Response to LRD Opinion

PROPOSED LARGE SCALE RESIDENTIAL DEVELOPMENT (LRD) AT SARSFIELD ROAD, WILTON, CORK CITY

APRIL 2025

Figure 4.0 Current Site Layout. The image outlines the proposed development's access points, layout, and permeability. [Source: Reddy Architecture + Urbanism, cropped and annotated by TPA 2025]

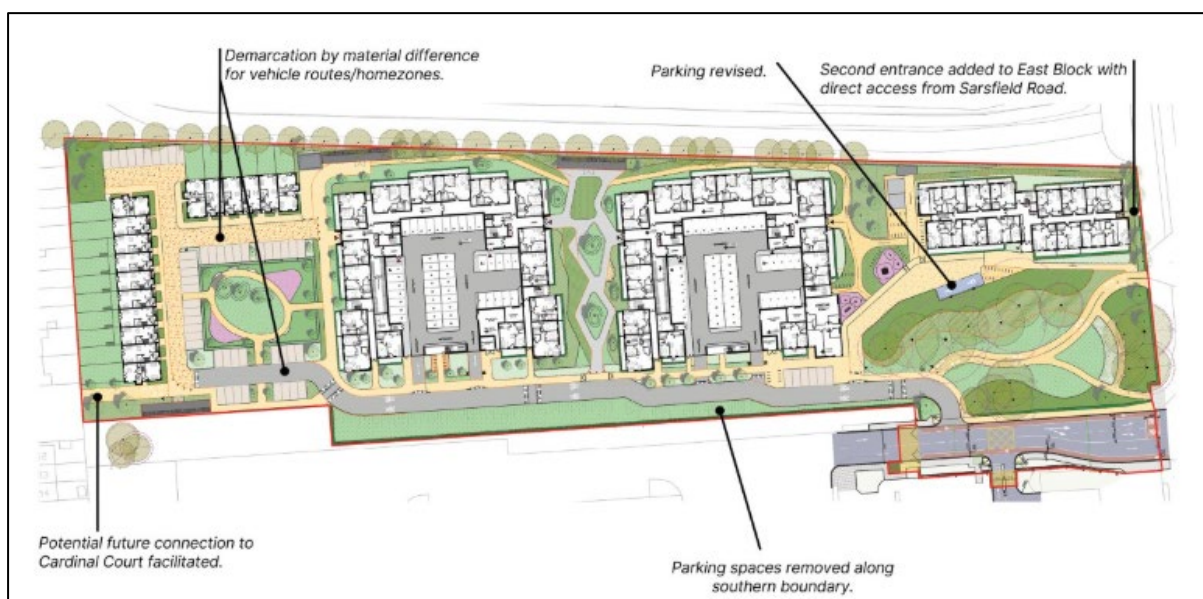
“The “Site Landscape Boundary Treatments” drawings imply an almost completely walled off development which goes against the preference for permeability. While the railing to the east and southeast appears to try to mimic the existing railing to the existing private greenfield site, it is not appropriate to continue this treatment to the proposed housing scheme and green spaces adjacent to this. The proposed 3 metre high brick wall added for security reasons to the south should also be reconsidered or at least reduced in height as it would be an oppressive and inappropriate addition to the scheme. This massive boundary to the south has also resulted in the removal of many existing trees which were previously proposed to be retained which reduces the quality of the landscaped area around the scheme”.

In response to the above, please refer to the accompanying Architectural Design Statement prepared by Reddy Architecture and Urbanism. The report outlines the proposed development’s layout and design evolution which prioritises permeability throughout the site. Boundary treatments were redesigned following feedback received by Cork City Council during consultation meetings accordingly.

The proposed development includes 2 no. access points to the east of the subject site providing direct access to Sarsfield Road. This allows the proposed development to actively engage with the street, creating an active street front and providing vibrancy. In addition, it is to be noted the proposed childcare facility is to be located near the front/eastern section of the site. Introducing an active use of this section of the site that will provide passive surveillance, increased foot traffic, and activity.

There is a provision of c. 3,545 sqm of public open space, which is envisioned to be a shared space for residents to use. In addition, as outlined throughout the planning application there is provision of a future connection to the adjoining residential estate Cardinal Court. This will allow future residents and members of the community to easily travel through the area.

Figure 4.1 S32B Stage vs. Current Proposed Scheme. [Source Reddy Architecture + Urbanism, cropped and annotated by TPA 2025]

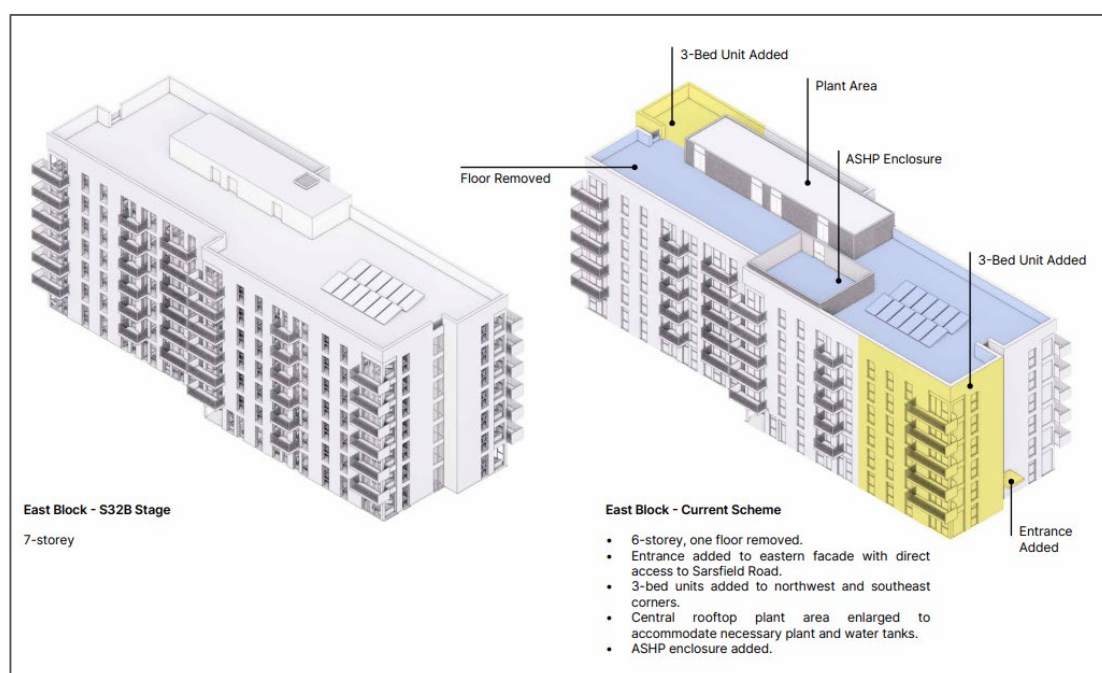
“The East Block is placed at the northern edge of the site which makes sense to allow for the retention of many existing mature trees to the southeast and create a well-designed landscaped buffer to the Sarsfield Road, which is effectively a 5 lane dual carriageway to the east. While the Sarsfield Road does not necessarily constitute a traditional street in its current format, the treatment of the east facade of the East Block should be reconsidered along with its massing and height to potentially provide more interaction with Sarsfield Road”.

In response to the above, please refer to the accompanying Architectural Pack prepared by Reddy Architecture and Urbanism. In order to address the comments from Cork City Council, a number of design changes have been implemented. We would like to highlight the height of the eastern block has been reduced from 7 no. storeys to 6 no. storeys, along with an additional entrance added to the eastern façade. The additional access point provides direct access to the adjoining street and Sarsfield Road.

We submit to the local authority that the proposed treatment of the east facade of the East Block massing and height is more sympatric to the receiving urban environment and provides increased interaction with Sarsfield Road.
